TO: Olivia Dias, Planner III
Community Development Department

FROM: Glenn J. Davis, PE, CFM, Chief Development Engineer 
Public Works Department

**SUBJECT: PUBLIC WORKS RECOMMENDATIONS
SPR-ADJ-DR20-21 (20-106698-RP)
1795 FAIRGROUNDS ROAD NE
6-UNIT MULTI-FAMILY DEVELOPMENT**

Class 3 Site Plan Review for a six-unit multi-family development on property approximately 7,345 square feet in size, zoned CO (Commercial Office), and located at 1795 Fairgrounds Road NE (Marion County Assessor Map and Tax Lot 073W23BA / 3600).

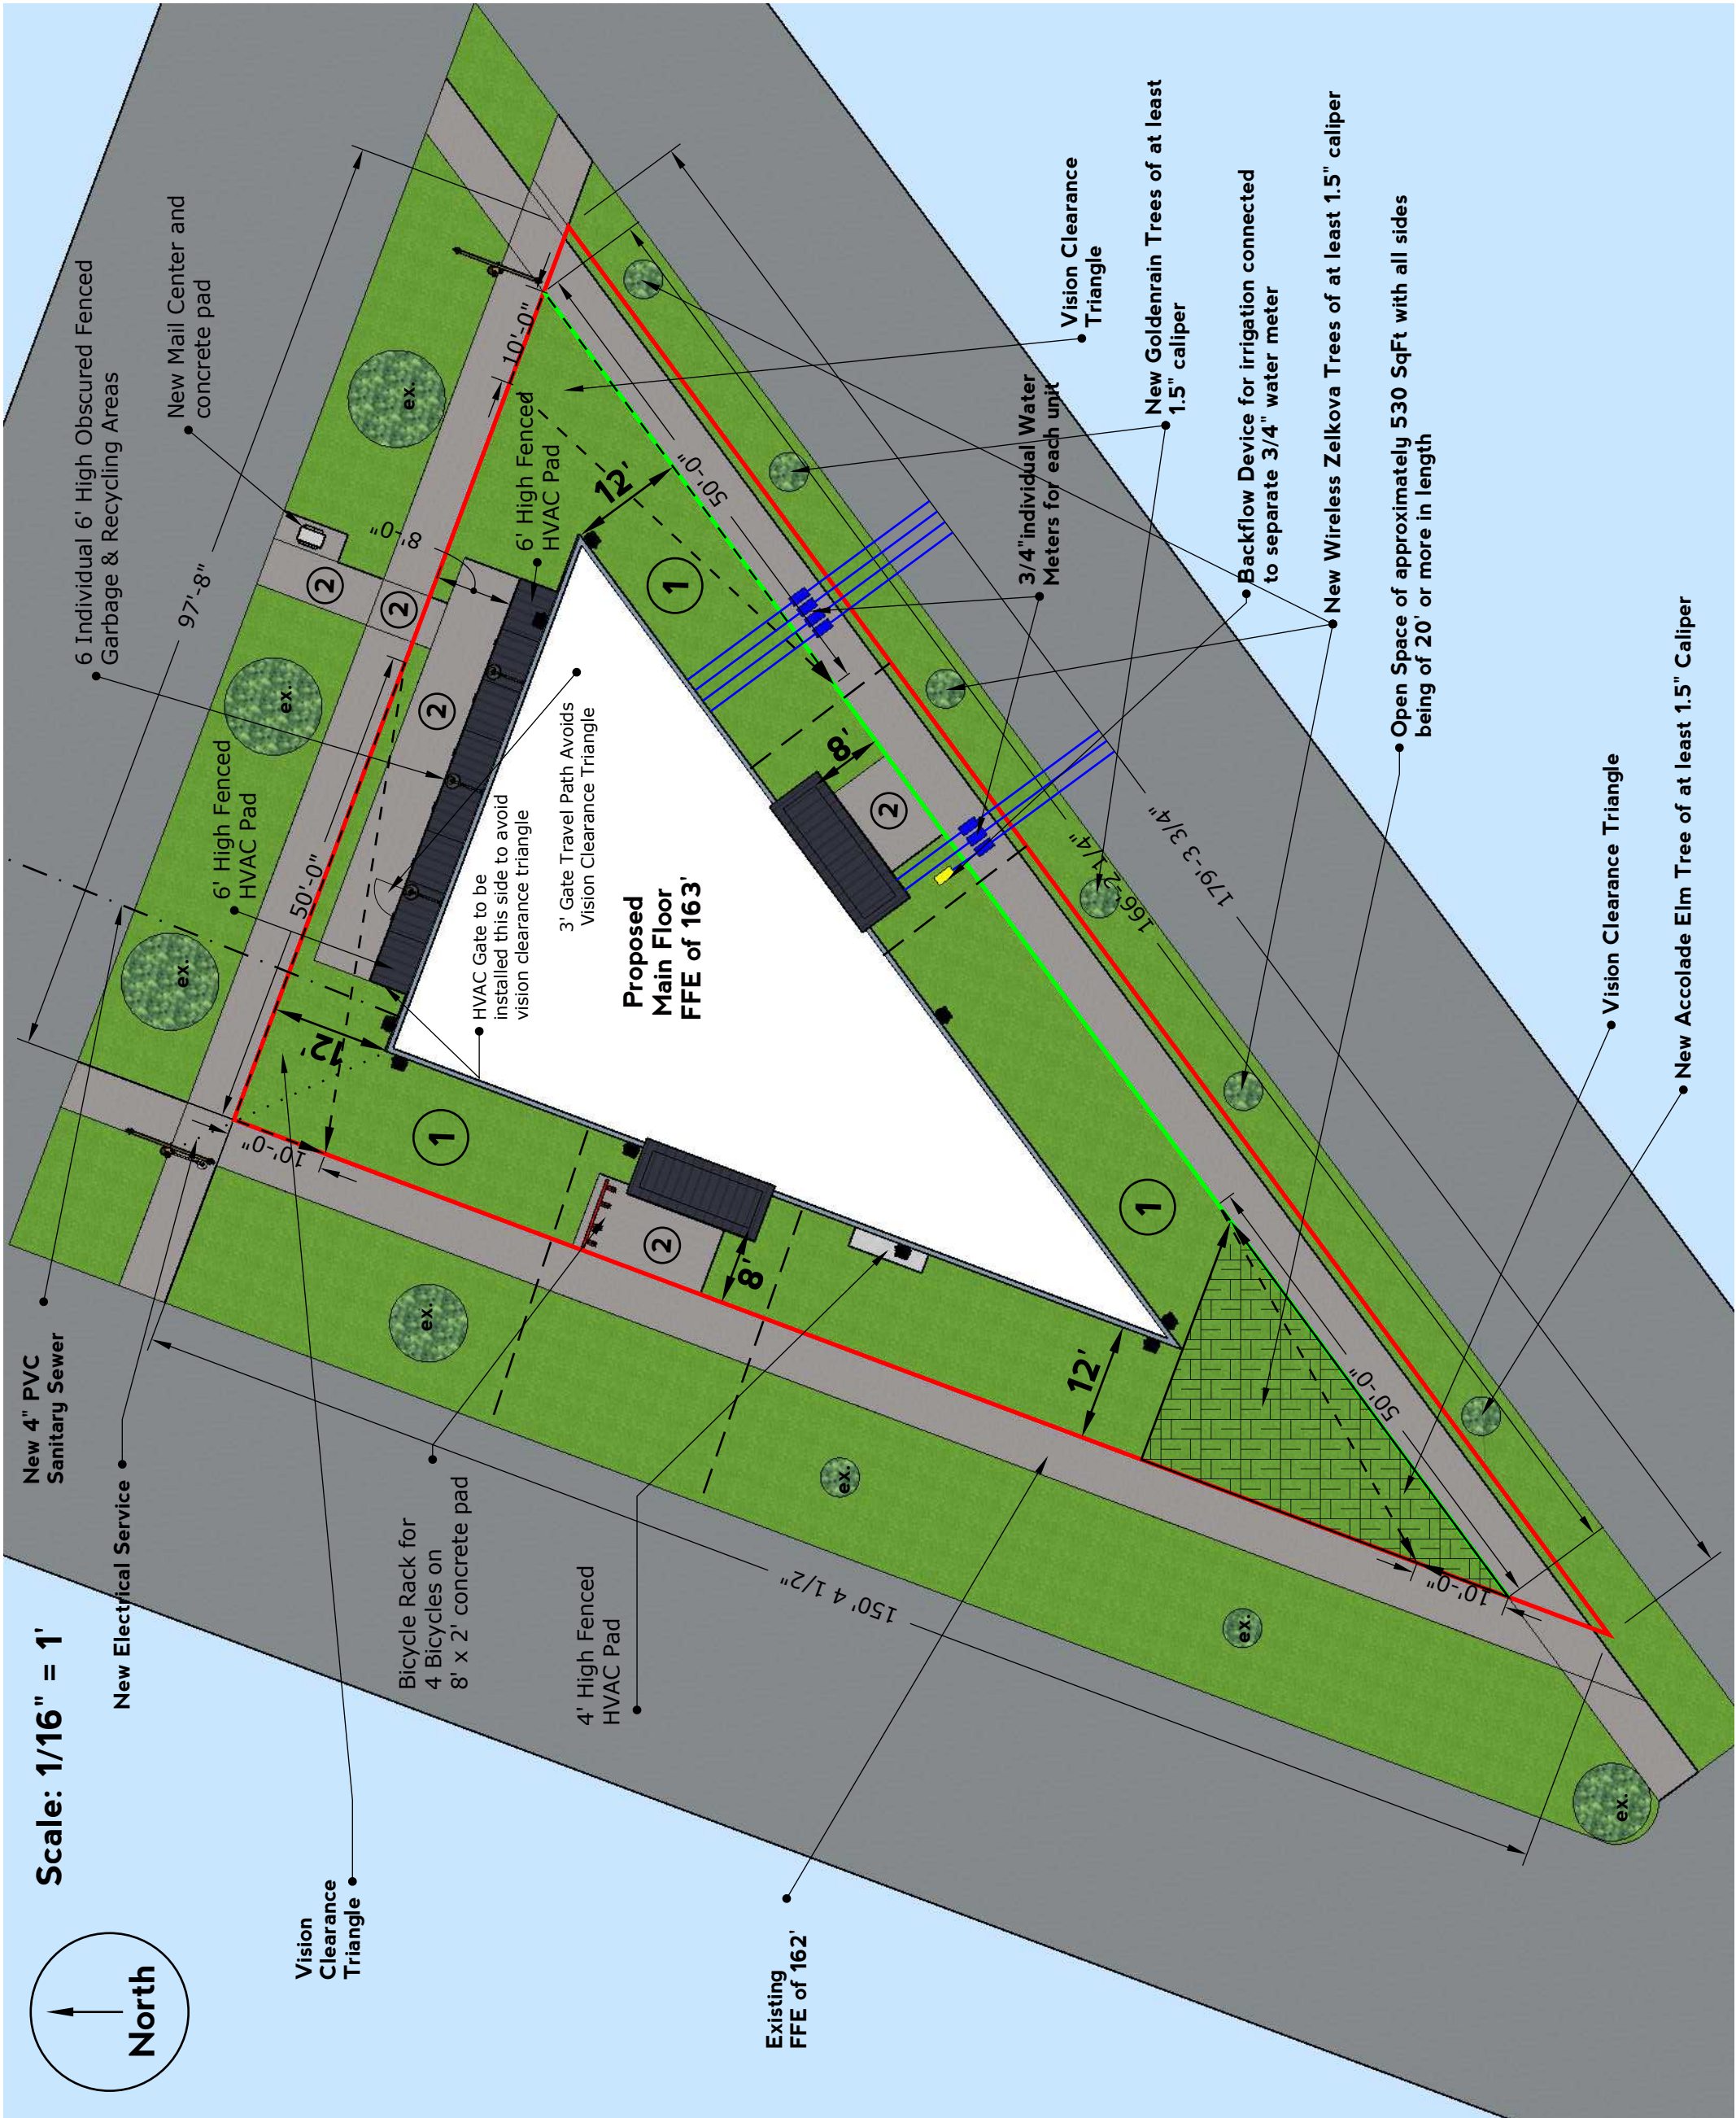
1. Convey land for dedication to equal a half-width right-of-way of 36 feet on the development side of Fairgrounds Road NE and sufficient right-of-way to accommodate public infrastructure at the property corners.
2. Remove the existing sidewalk and construct sidewalk parallel to and one foot from the adjacent right-of-way along the Fairgrounds Road NE frontage of the property.
3. Provide street trees to the maximum extent feasible along all property frontages pursuant to SRC 86.015(e).

Finding—The existing condition of Fairgrounds Road NE does not meet current right-of-way standards for its classification of street per the Salem TSP. The applicant shall convey for dedication a half-width right-of-way up to 36 feet to Minor Arterial street standards and adequate right-of-way at the property corners as specified in the PWDS. The Director has authorized an alternative street standard for the street improvement width of Fairgrounds Road NE pursuant to SRC 803.065(a)(2). However, the existing sidewalk does not meet accessibility standards, and the applicant shall be required to construct sidewalk parallel to and one foot from the adjacent right-of-way along the Fairgrounds Road NE frontage of the property. In addition, the street is lacking street trees; therefore, the applicant shall provide street trees to the maximum extent feasible pursuant to SRC 86.015(e) along the Fairgrounds Road NE frontage.

Finding—The Public Works Department has reviewed the applicant's preliminary plan for this site. The water, sewer, and storm infrastructure are available within surrounding streets/areas and are adequate to serve the proposed development. However, the applicant has proposed to connect new water meters to the existing 2-inch main in Fairgrounds Road NE, which is not adequate to serve the proposed development. New water meters shall be taken from either the 8-inch water main in Madison Street NE or the 8-inch water main in Winter Street NE.
